WIRING SCHEMATIC DIAGRAM 480V LC ACB (ESSENTIAL) 52-303
SCHEME NO. 18303 (CONTINUED ON E104 <2A>)

DCP 1430 REV 0

4160V & 480V SYSTEM CONTROL & PROTECTION

JOB NO.	DRAWING NO.	SH.	REV.
7884	BECH-E104 <17A>	0	0

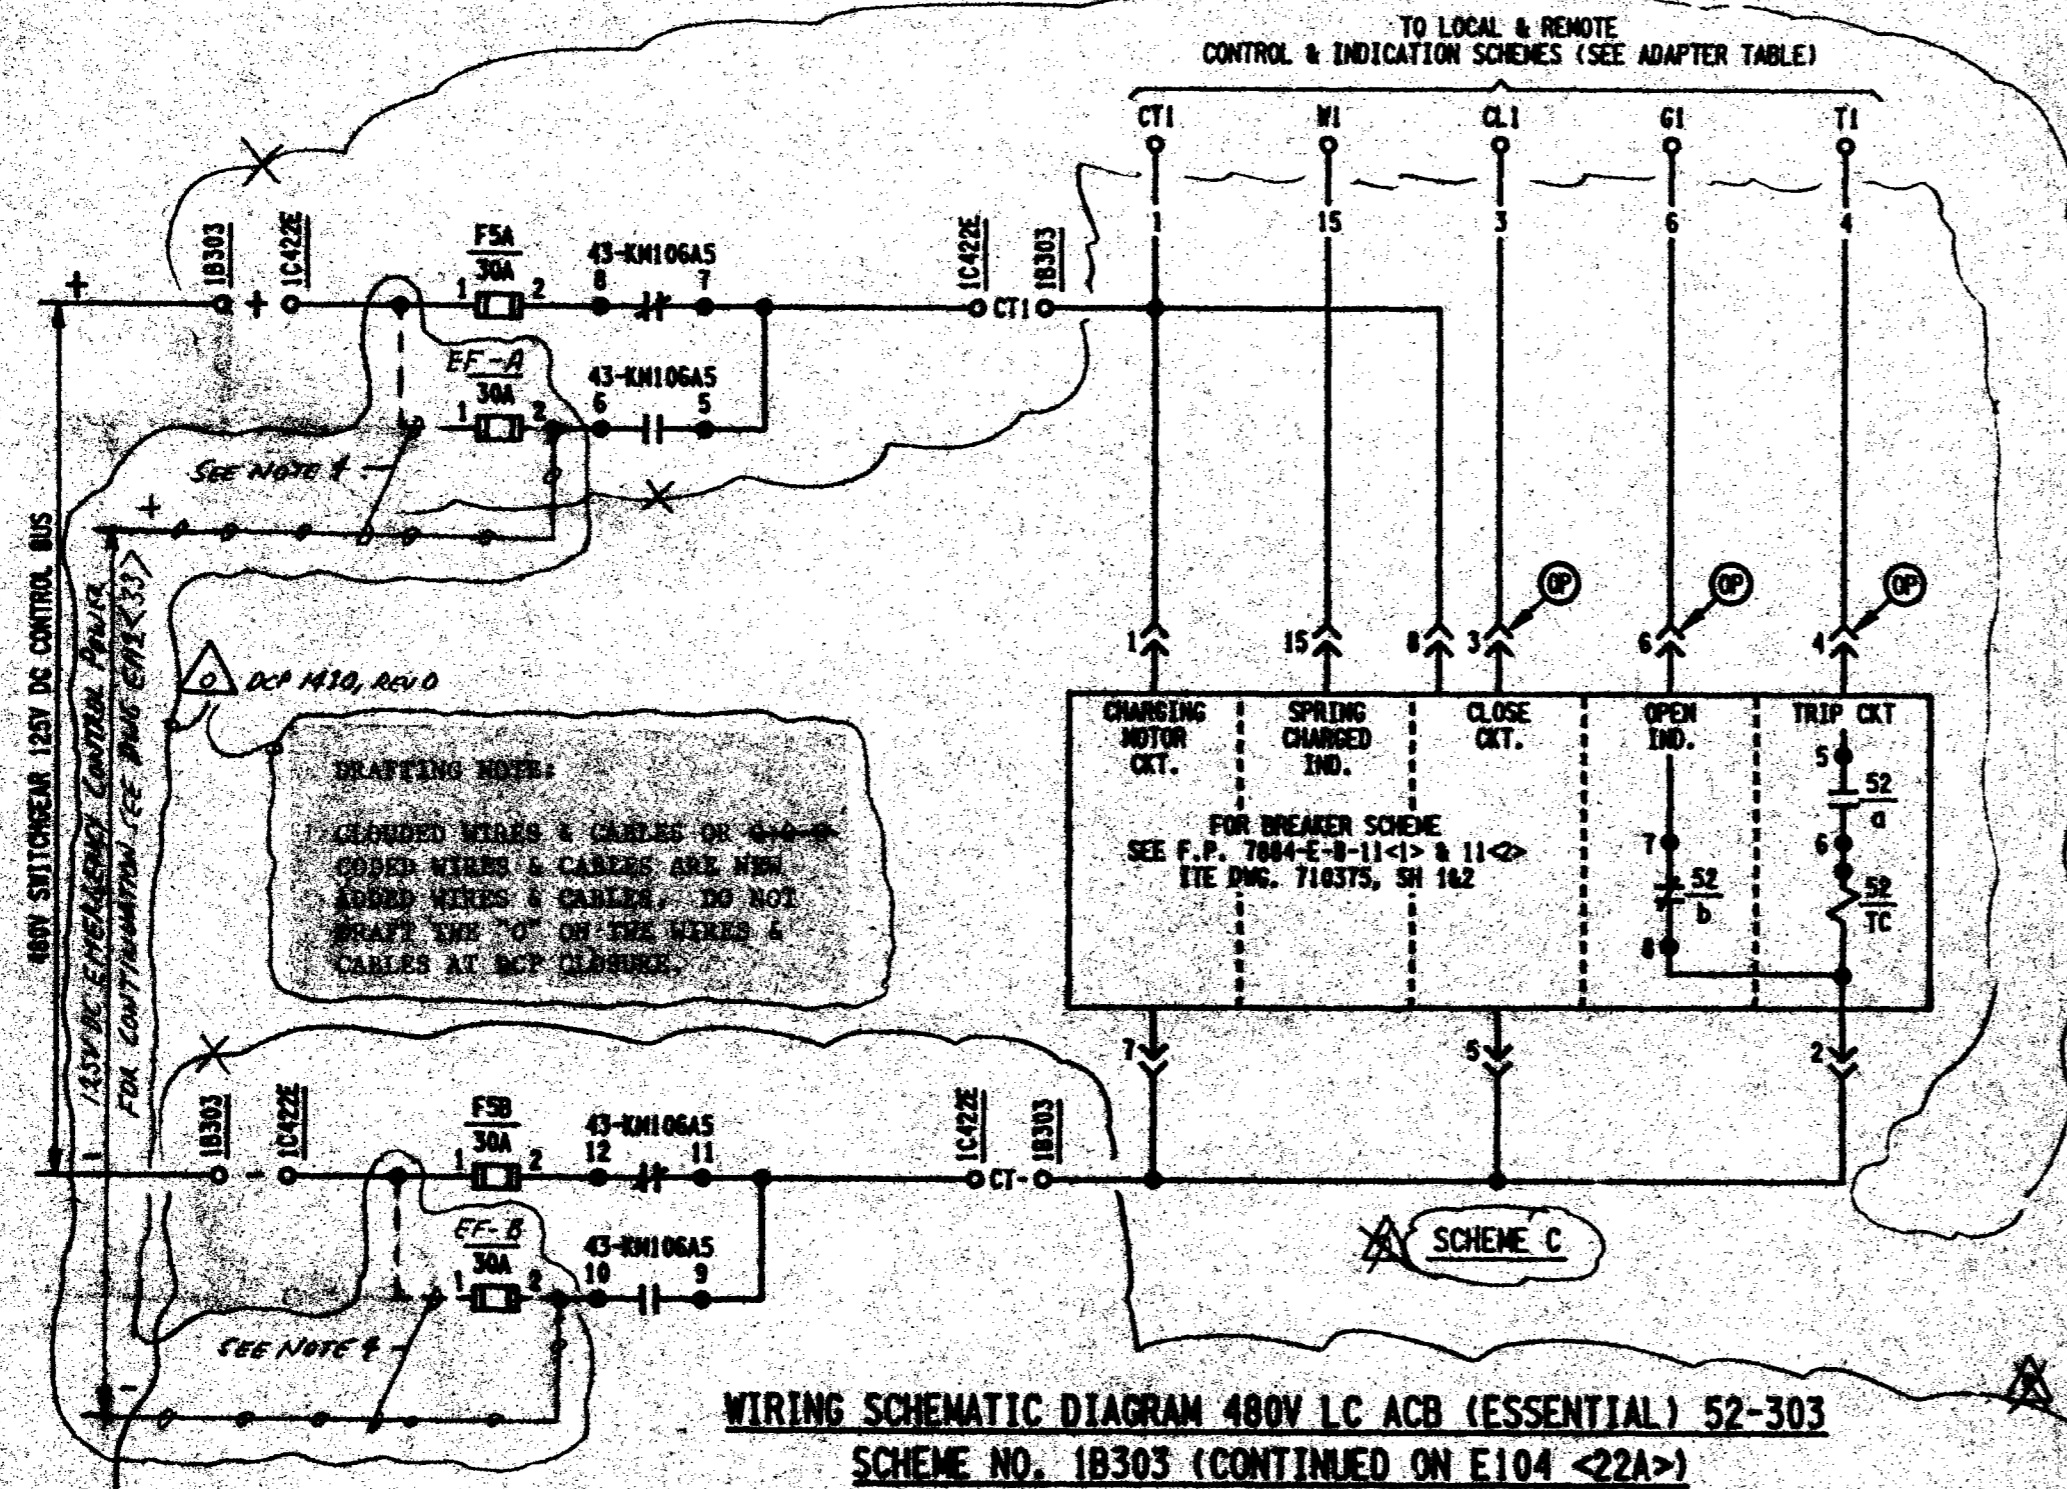
SPECIAL NOTE FOR REV 0
This drawing is derived from Drawing E-104, Sh 17, Rev 1. Revised portions of the referenced drawing have been circled. This note is to be removed prior to issuance of Rev 1.
